NGCP's Position on the Other Comments/Arguments of VECO, PEPOA, and GMC

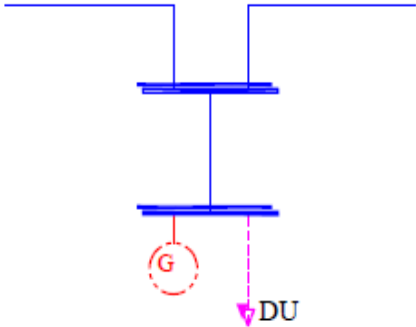
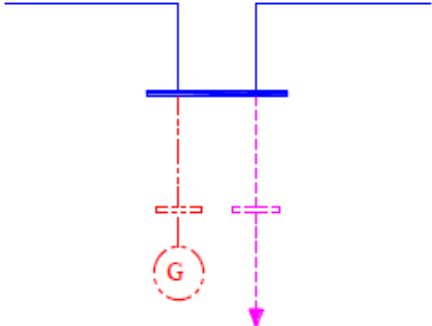
SUBJECT/AREA/ITEM	DISCUSSION OF ARGUMENTS	NGCP'S POSITION
		<u>Therefore, the dedicated point to point limited transmission facilities include both Equipment and transmission lines.</u>
Case 1: Generation plant's radial/direct connection to grid.	<p>Assumption: Standard interconnection of a prospective generation plant to the grid.</p> <p>Sketch:</p> 	<ul style="list-style-type: none"> • NGCP agrees.
Case 2: Generation plant with multi-sited generation installations (same owner).	<p>Assumption: Such set-up is under the circumstance of a reasonably distant location or is intended for no other interest but the aggregation capacity.</p>	<ul style="list-style-type: none"> • NGCP agrees.

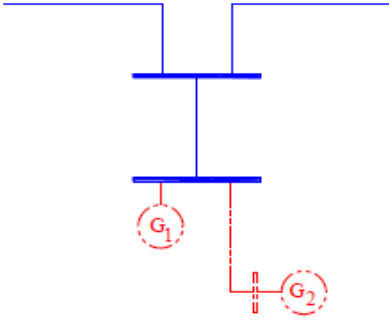
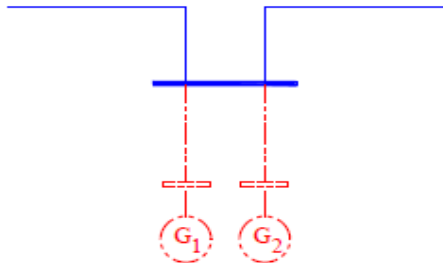
SUBJECT/AREA/ITEM	DISCUSSION OF ARGUMENTS	NGCP'S POSITION
	<p>Sketch:</p>	
<p>Case 3. Generation plant with an embedded Load Customer (DU).</p>	<p>Assumption: While Sec. 5a(i) of the IRR of EPIRA sets a condition for limited transmission facilities to not serve End-Users or Suppliers directly, the Committee resolved that a Distribution Utility (but not a directly-connected End-User) may be permitted to draw power directly from the generation plant's switchyard.</p> <p>However, such arrangement should be subject for a System Impact Study (SIS) to validate that the DU's connection to the switchyard of the generator will have negligible impact to the grid's normal operation. Otherwise, the treatment for the assets based on functionality will be as shown on Sketch B.</p>	<ul style="list-style-type: none"> • NGCP disagrees on the argument of GMC. <p>NGCP reiterates the Section 9 of the EPIRA which states,</p> <p><i>“A generation company may develop and own or operate dedicated point to point limited transmission facilities that are consistent with the TDP: Provided, That such facilities are required only for the purpose of connecting to the transmission system, and are used solely by the generating facility, subject to prior authorization by the ERC: Provided, further, That in the event that such assets are required for competitive purposes, ownership of the same shall be</i></p>

SUBJECT/AREA/ITEM	DISCUSSION OF ARGUMENTS	NGCP'S POSITION
	<p>On a significant technical perspective, based on experience, a direct connection of a Load to the generator's facility will benefit both during grid disturbance in the manner that the generator will run on an island mode. It will not require a long duration of wait for the generator to start up nor will it disrupt the supply of its connected Load.</p> <p style="text-align: center;">Sketch A:</p> <div style="text-align: center;">  <p>The diagram, labeled 'Case 3', illustrates a power system configuration. At the top, there are two horizontal blue lines representing a busbar or main supply lines. A vertical blue line connects this busbar to a thick horizontal blue line representing a generator's terminal bus. From this terminal bus, a vertical red dashed line extends downwards to a horizontal red dashed line representing a load bus. A circle containing the letter 'G' is connected to the bottom of the red dashed line, representing the generator. To the right of the load bus, a vertical purple dashed line with a downward-pointing arrowhead is labeled 'DU', representing a load or disturbance unit.</p> </div>	<p><i>transferred to the TransCo at a fair market price: Provided, finally, that in the case of disagreement on the fair market price, the ERC shall determine the fair market value of the asset". (emphasis supplied)</i></p>

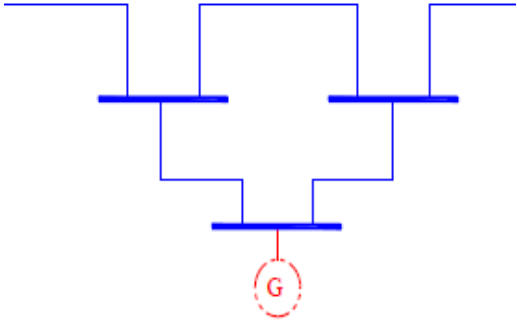
SUBJECT/AREA/ITEM	DISCUSSION OF ARGUMENTS	NGCP'S POSITION
	<p>Sketch B:</p> <p style="text-align: center;">Case 3</p> 	
<p>Case 4: Generation plant in parallel with a Load Customer.</p>	<p>Assumption: The Load Customer can either be a DU or a directly-connected End-User.</p> <p>Sketch:</p> <p style="text-align: center;">Case 4</p> 	<ul style="list-style-type: none"> • NGCP agrees.
<p>Case 5. Generation plant traversing another Generation plant's (different owner) substation</p>	<p>Assumption: Initial set-up is as illustrated by the standard connection of Case 1. In the event that</p>	<ul style="list-style-type: none"> • NGCP agrees.

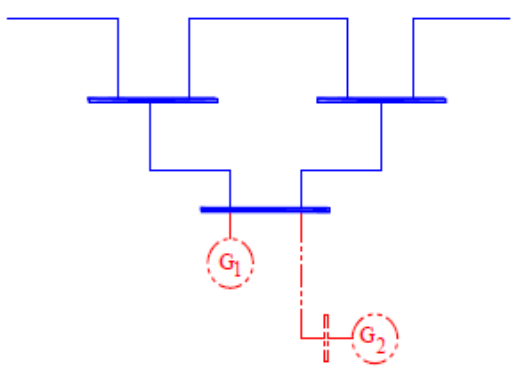
SUBJECT/AREA/ITEM	DISCUSSION OF ARGUMENTS	NGCP'S POSITION
<p>facility to the grid.</p>	<p>G1 <u>grants</u> the interconnection of G2 to its facility, the treatment for the assets based on functionality will be as shown.</p> <p>Additionally, if it is contemplated that another User is to connect to the Generator's switchyard facility, the provision of Rule 5 a (i) from the IRR of RPIRA shall be invoked. Should the interconnection be pursued, it shall be subject to the following:</p> <ol style="list-style-type: none"> 1. A consent form the Generator to concede with the interconnection allowing its own facilities to perform a transmission function. 2. An SIS prior to connection. 3. A tri-partite agreement between the Generator, the other User, and the Transmission Provider as to boundary, ownership, and classification of the assets 4. Amendment of the Connection Agreement between the initial Generator and the Transmission Provider.

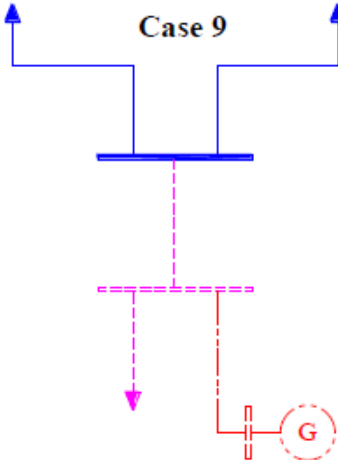
SUBJECT/AREA/ITEM	DISCUSSION OF ARGUMENTS	NGCP'S POSITION
	<p style="text-align: center;">Sketch:</p> <p style="text-align: center;">Case 5</p> 	
<p>Case 6: Generation plant in parallel with another Generation plant.</p>	<p>Assumption: Standard interconnection of prospective parallel generation plants delivering power to the grid.</p> <p style="text-align: center;">Sketch:</p> <p style="text-align: center;">Case 6</p> 	<ul style="list-style-type: none"> • NGCP agrees.
<p>Case 7: Generation plant looped on two transmission substation facilities.</p>	<p>Assumption: For reliability purposes, the Generation plant grants set-up subject to an agreement between itself and the Transmission</p>	<ul style="list-style-type: none"> • NGCP agrees.

SUBJECT/AREA/ITEM	DISCUSSION OF ARGUMENTS	NGCP'S POSITION
	<p>Provider.</p> <p>The Generation plant's facility has a transmission function in the manner that it completes a loop in the delivery power from one transmission substation to the other. By this mere reason, it has significant impact to the normal operation of the grid.</p> <p>Sketch:</p> <p style="text-align: center;">Case 7</p> 	
<p>Case 8: Generation plant traversing another Generation plant's facility which is looped on two transmission substation facilities.</p>	<p>Assumption: There is a common utilization of the Generation plant G1's facility so it has a transmission function in the manner that any disturbance therewith affects the grid and another User.</p>	<ul style="list-style-type: none"> • NGCP agrees.
